REGIONAL REVIEW FINDING

Submitting Local Government: City of Atlanta
Name of Proposal: Coventry Station

Preliminary Report:	Jan 31, 2005	DEVELOPMENT OF REGIONAL IMPACT REVIEW REPORT	Project:	Coventry Station #659
Final Report Due:	March 2, 2005		Comments Due By:	Feb. 14, 2005

PRELIMINARY SITE PLAN
SCALE: 1" = 100'

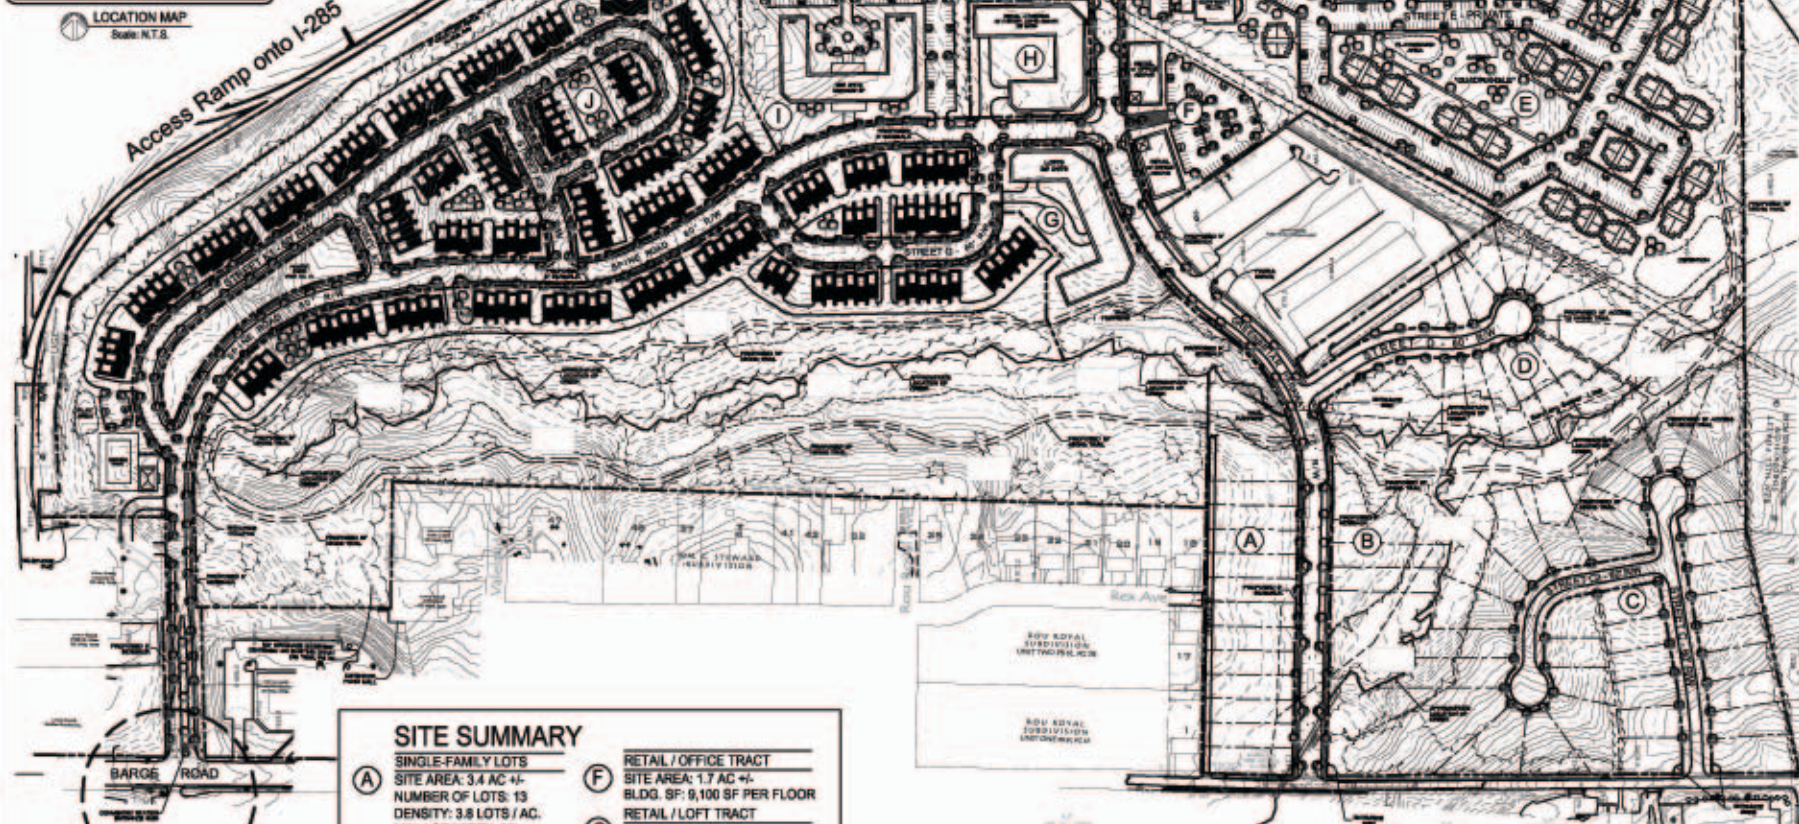
However, there are several improvements that can be made to the site plan to ensure the overall development better meets or exceeds ARC Regional Development Policies and the goals of the LCI plan. It is strongly recommended that the site plan reflect a more direct connection from the apartment complex to the retail uses located on Greenbriar Parkway. This should include additional paths for pedestrian and bicyclists. Best Transportation Practices 9 and 10 emphasize alternative routes and shortcuts for pedestrians and bicyclists that are of the standard as the network for motorist.

It is also strongly encouraged that pedestrian and trail access be provided to the residents along Rex Avenue. This will provide those residents with a safe alternate to the retail located along Greenbriar Parkway as well as to the trails that are proposed in the open space areas of the development.

Finally, it is recommended that where applicable, right of way is preserved for future connection of streets. This would allow for continued implementation success of the LCI plan that calls for improved circulation for both the automobile and the pedestrian.

Regarding connectivity to the existing neighborhood located immediately to the west of the site, the Bureau would like to see street connections to the existing grid made where they are not limited by topography. At a minimum, the Bureau has requested that these connections not be precluded from being made in the future by reserving the necessary land for future improvement as connecting streets and not selling it as developable lots.
